**SITE PLAN REVIEW SHEET
ENVIRONMENTAL VARIANCE REQUEST ONLY**

CASE: SP-2021-0015D

PROJECT NAME: Crossroads Logistics

PROPOSED DEVELOPMENT: Industrial manufacturing warehouses

SHEET
26 of 84

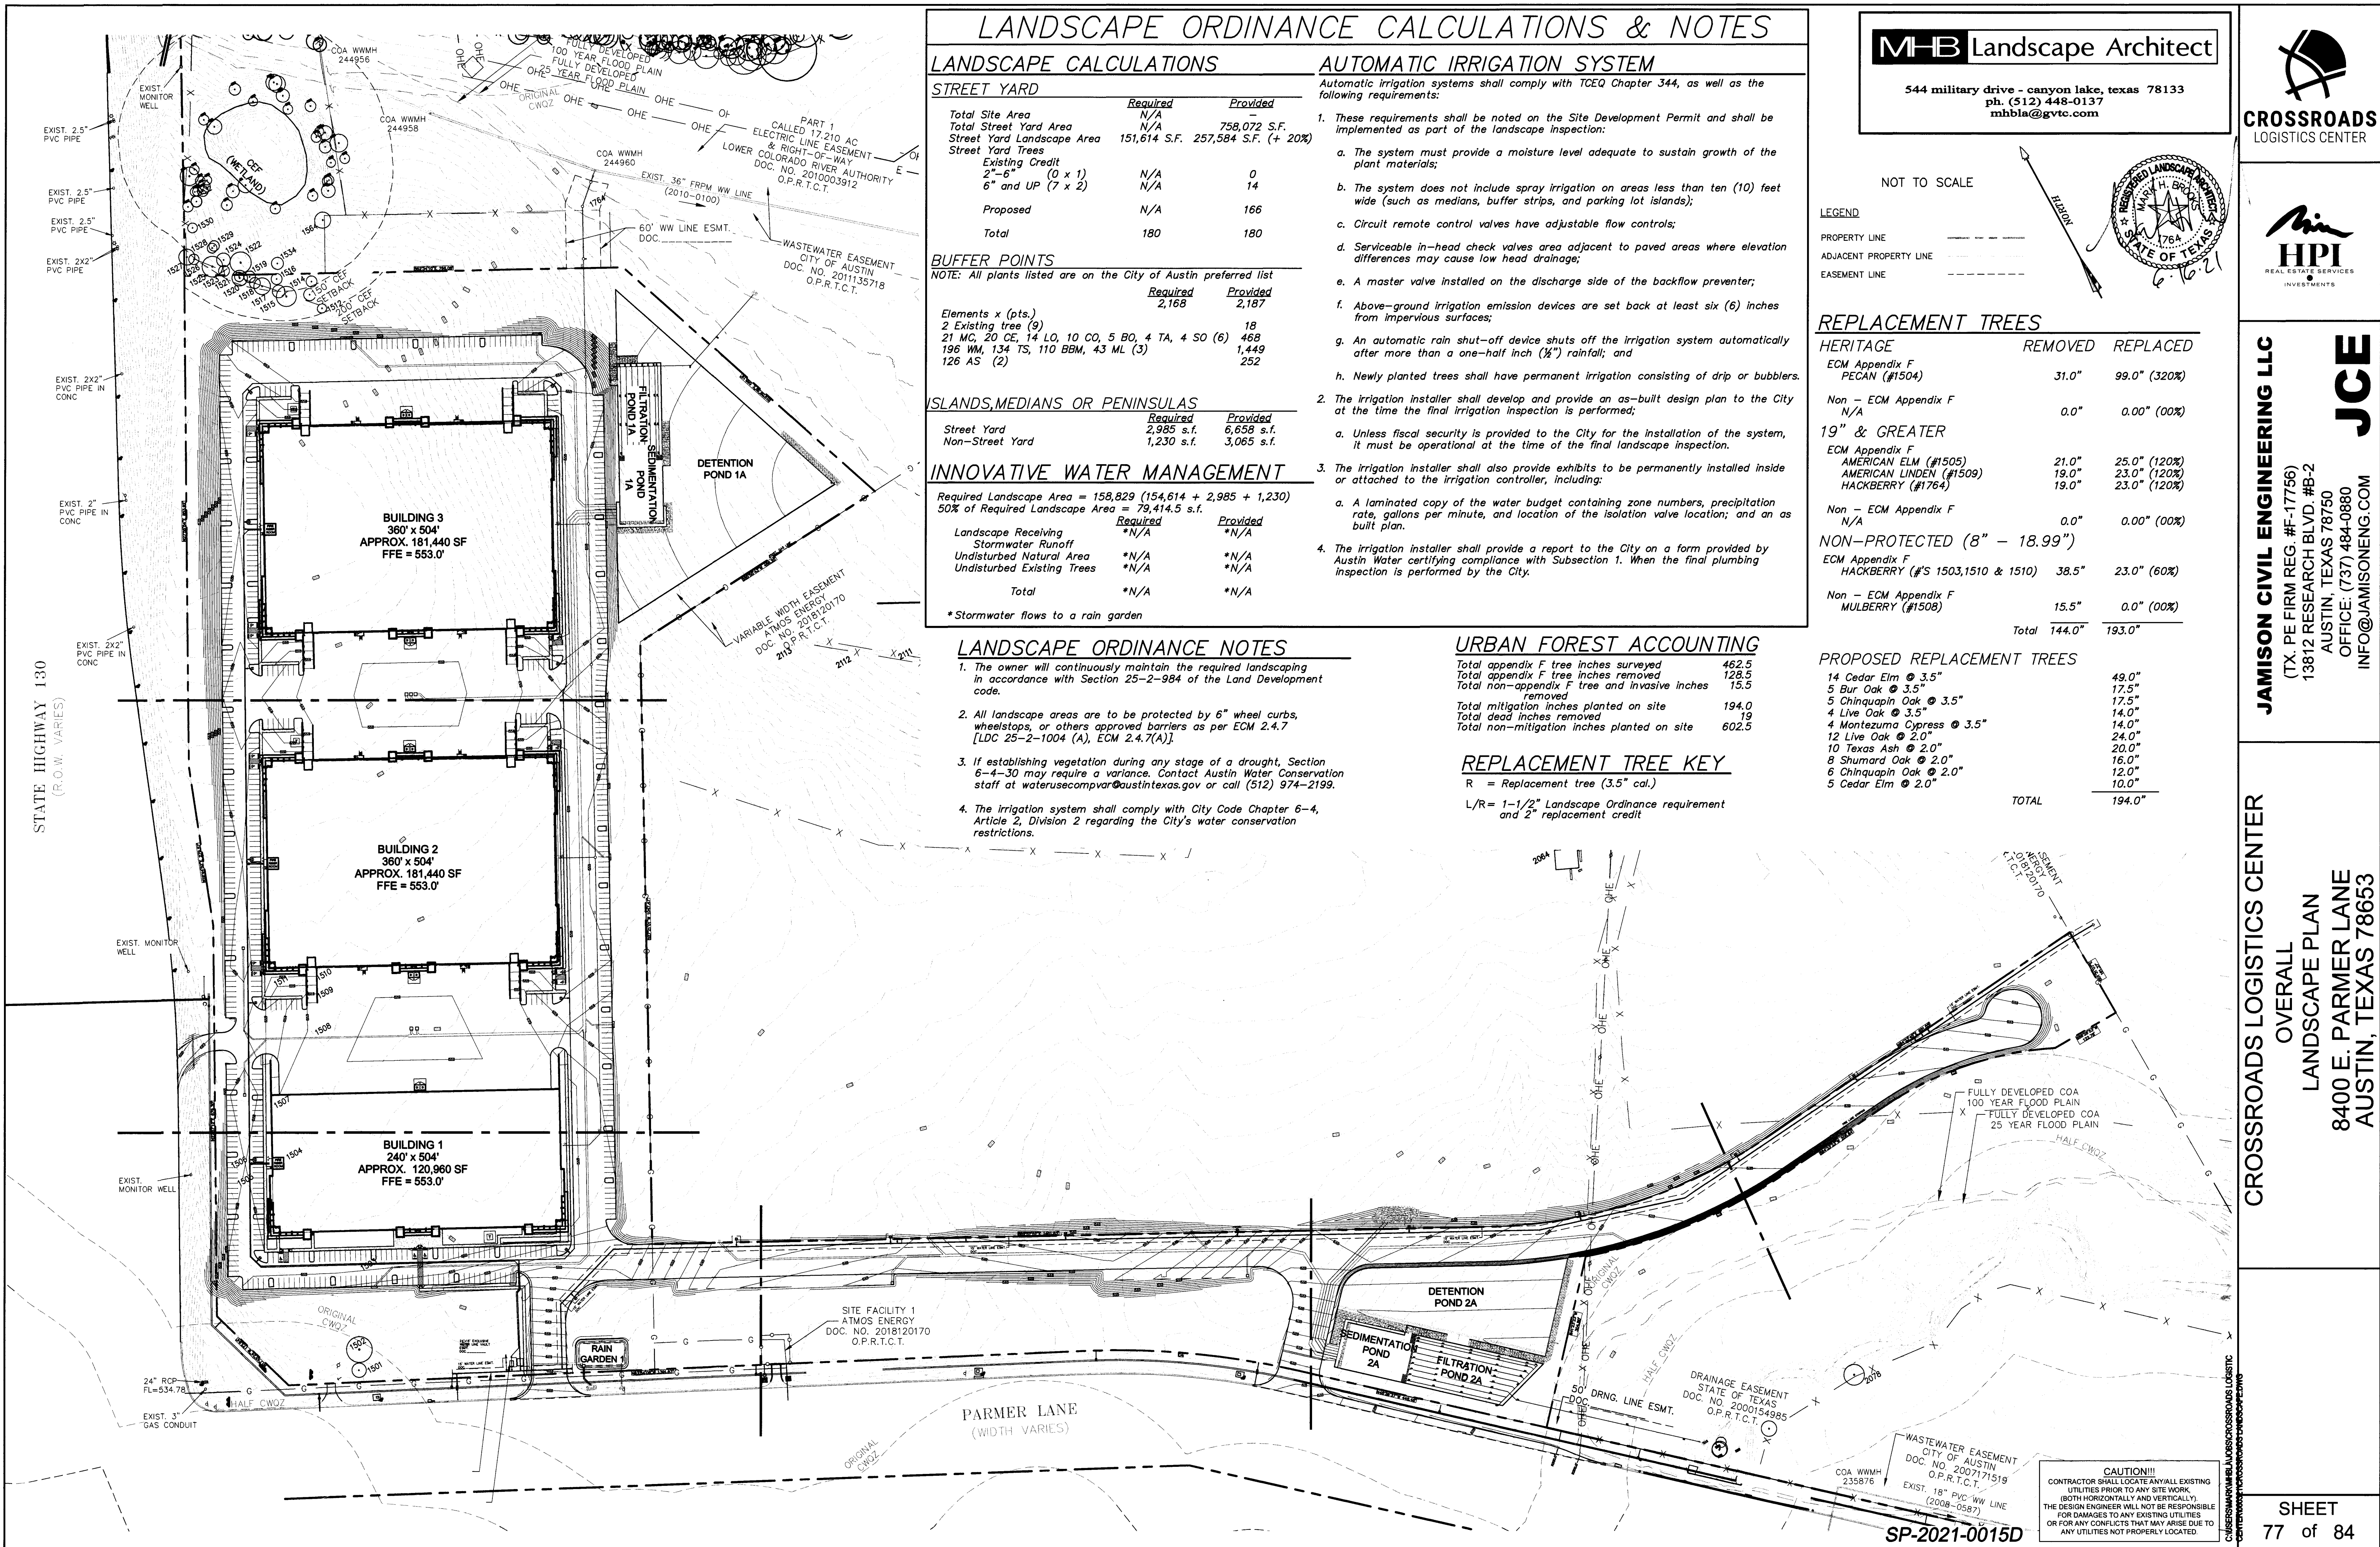
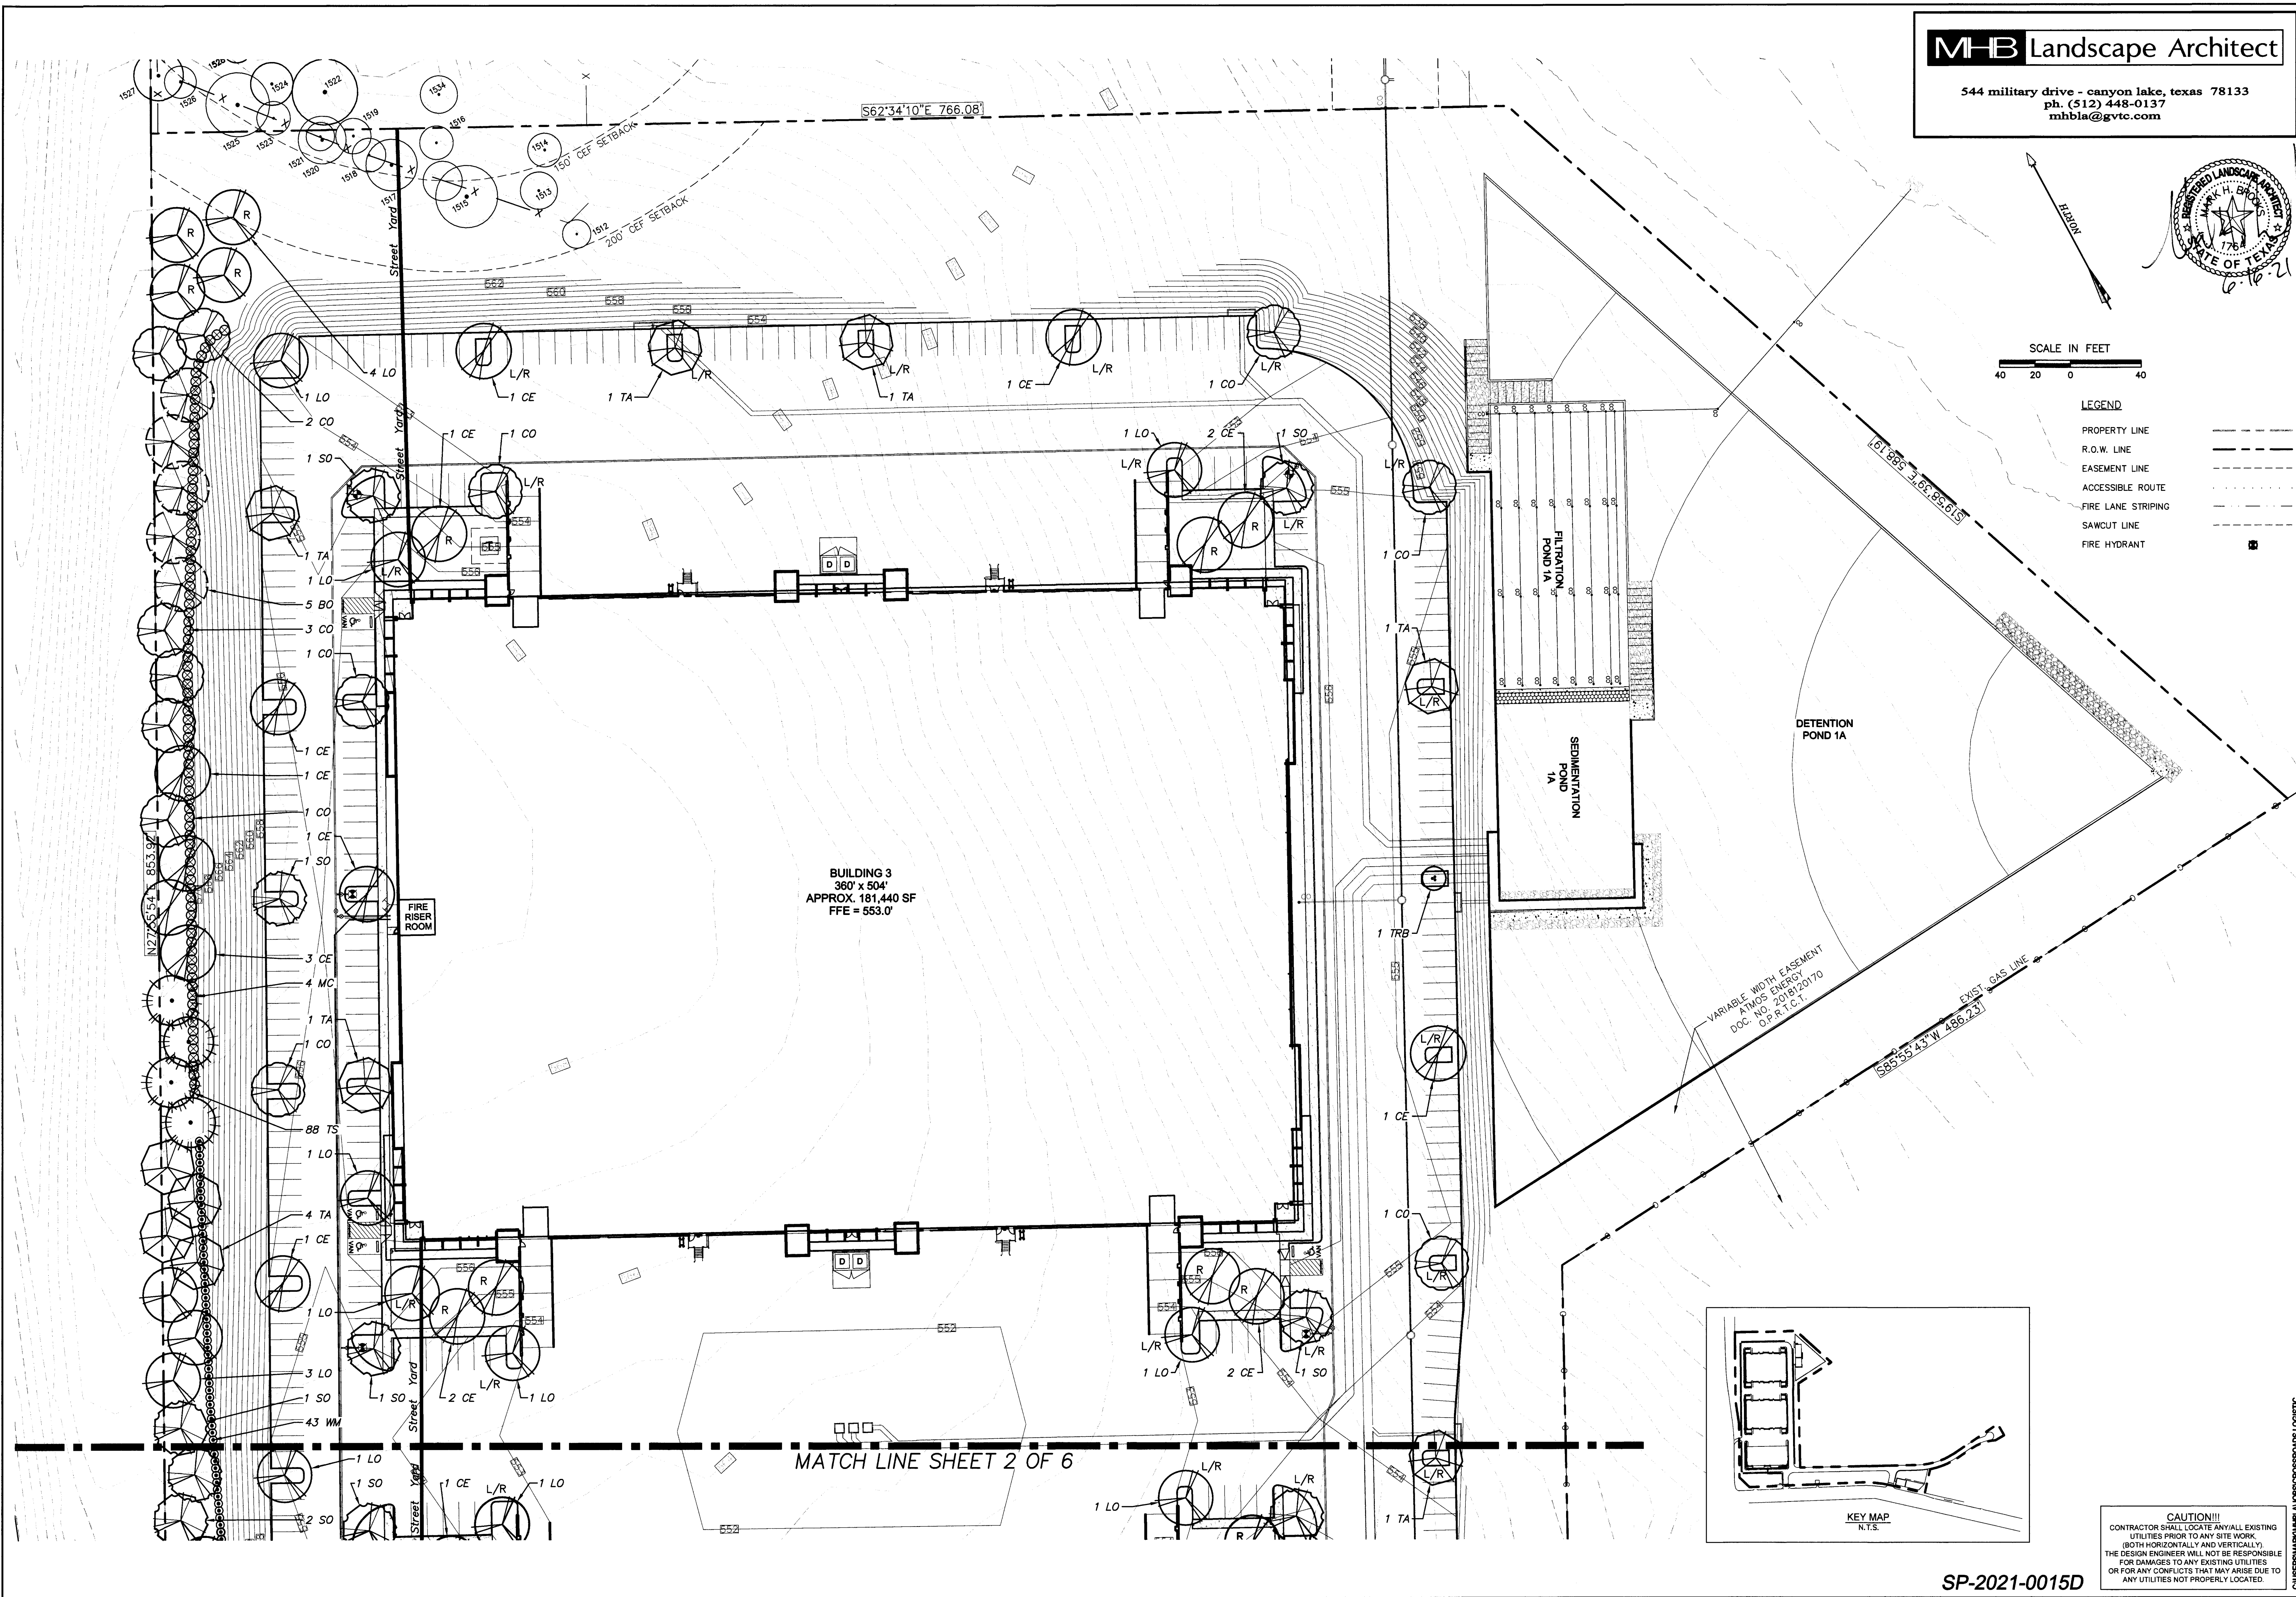
1. Request to vary from LDC 25-8-341 to allow cut up to 14.3 feet within the Desired Development Zone.
2. Request to vary from LDC 25-8-342 to allow fill up to 16.5 feet within the Desired Development Zone.

For the proposed project the situation is nearly identical. Due to the natural topography and the size of the buildings, 14.3 feet of cut is necessary to maintain level finish floor elevations, level truck courts, and truck lanes with grades less than 4%. Therefore, by not allowing this variance would deprive the applicant of a privilege available to owners of similarly situated property.

For the proposed project the situation is nearly identical. Due to the natural topography and the size of the buildings, 16.5 feet of fill is necessary to maintain level finish floor elevations, level truck courts, and truck lanes with grades less than 4%. Therefore, by not allowing this variance would deprive the applicant of a privilege available to owners of similarly situated property.

- Provide a landscape plan in accordance with City zoning jurisdictional requirements.
- Provide tree replacement/mitigation plan in accordance with City zoning jurisdictional requirements.
- Increase the wetland CEF setback from 150 feet to 200 feet.
- Provide structural containment of the cut with retaining walls.

- Provide a landscape plan in accordance with City zoning jurisdictional requirements.
- Provide tree replacement/mitigation plan in accordance with City zoning jurisdictional requirements.
- Increase the wetland CEF setback from 150 feet to 200 feet.
- Provide structural containment of the fill with retaining walls.

PROPOSED SITE PLAN & GRADING

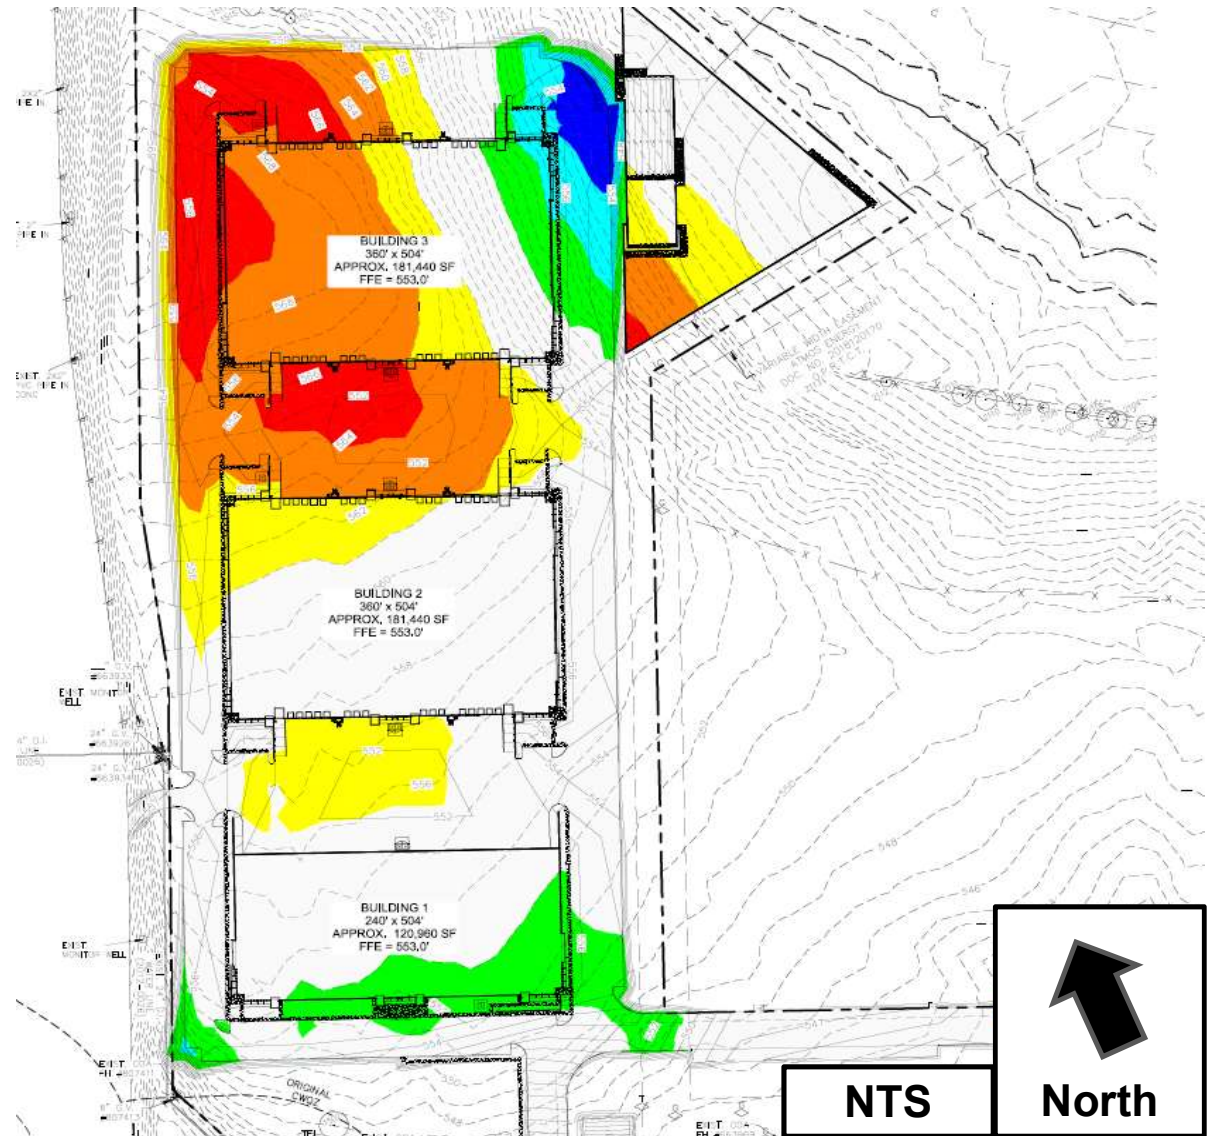
MAXIMUM CUT = 14.3 FEET
MAXIMUM FILL = 16.5 FEET

- Due to the topography of the site and the size of the proposed buildings (each approximately 4 acres in size), in order to accomplish the operational criteria, cut up to 14.3 feet and fill up to 16.5 feet are necessary.
- It can be challenging to find property flat enough to prevent the required amount of grading. Therefore, staff is requiring retaining walls to structurally contain the cut and fill and minimize the amount of grading.
- The project proposes environmental protections such as expanding the wetland CEF setback from 150 feet to 200 feet. It also proposes to provide landscaping and tree replacement & mitigation in accordance with City zoning jurisdictional requirements – something not required by code within the City's Extra Territorial Jurisdiction.

- Provide a landscape plan in accordance with City zoning jurisdictional requirements.
- Provide tree replacement & mitigation plan in accordance with City zoning jurisdictional requirements.
- Increase the wetland CEF setback from 150 feet to 200 feet.
- Provide structural containment of the cut & fill with retaining walls.

SITE PLAN ENLARGEMENT

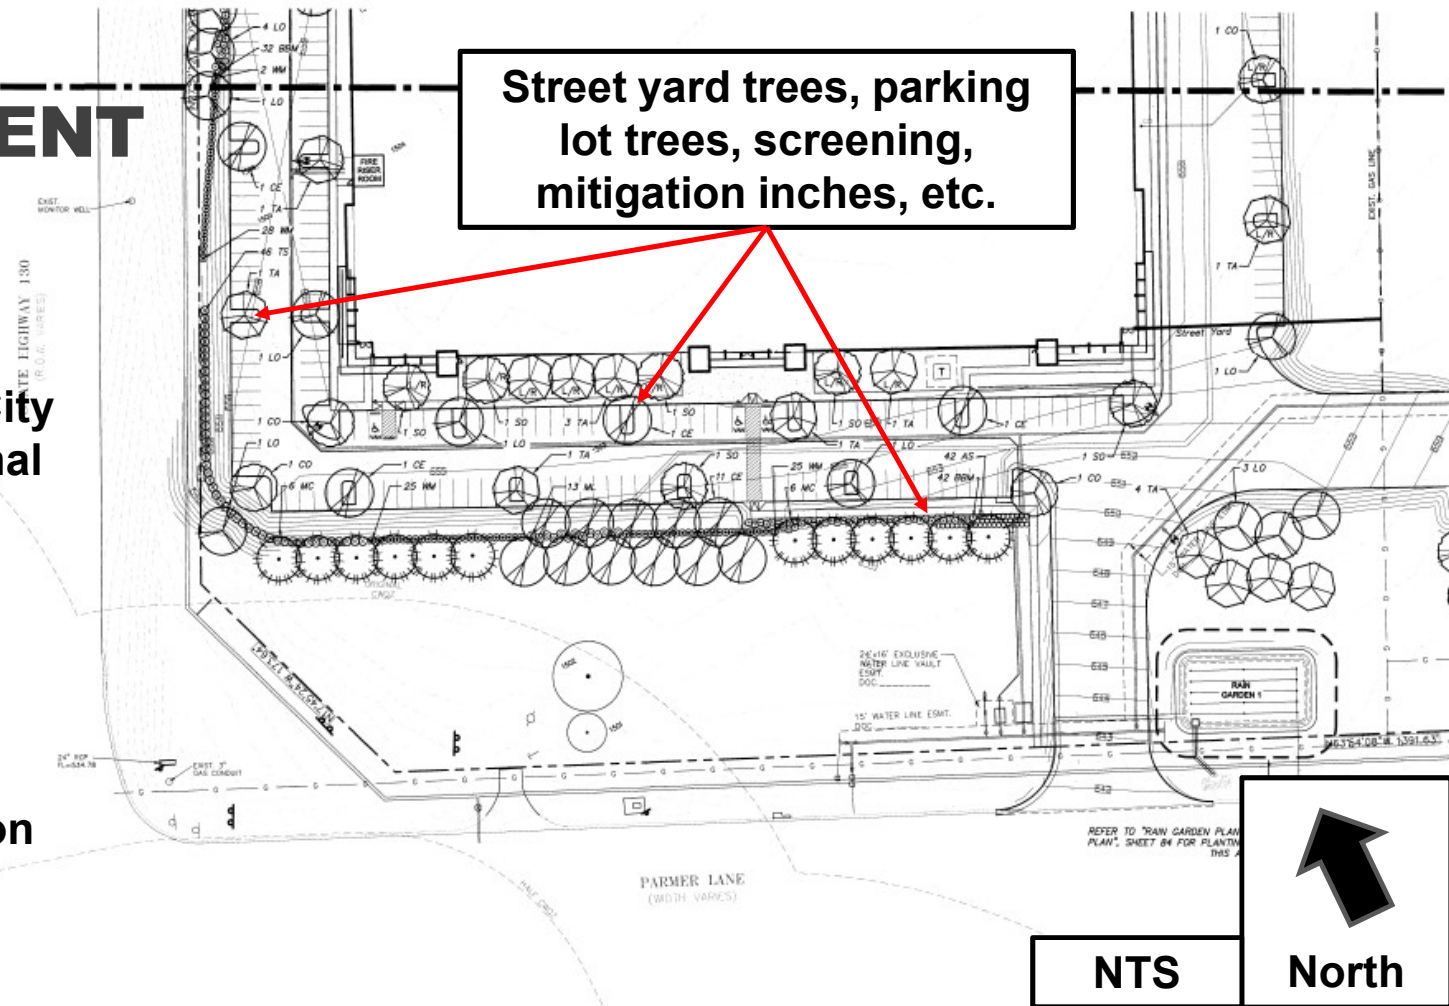
- Wetland CEF setback expanded from 150 feet to 200 feet
- Retaining walls to structurally contain cut and fill and minimize the amount of grading

- Landscaping and tree replacement / mitigation in accordance with City zoning jurisdictional requirements
- Total mitigation inches planted on site is a 194
- Total non-mitigation inches planted on site is 602.5
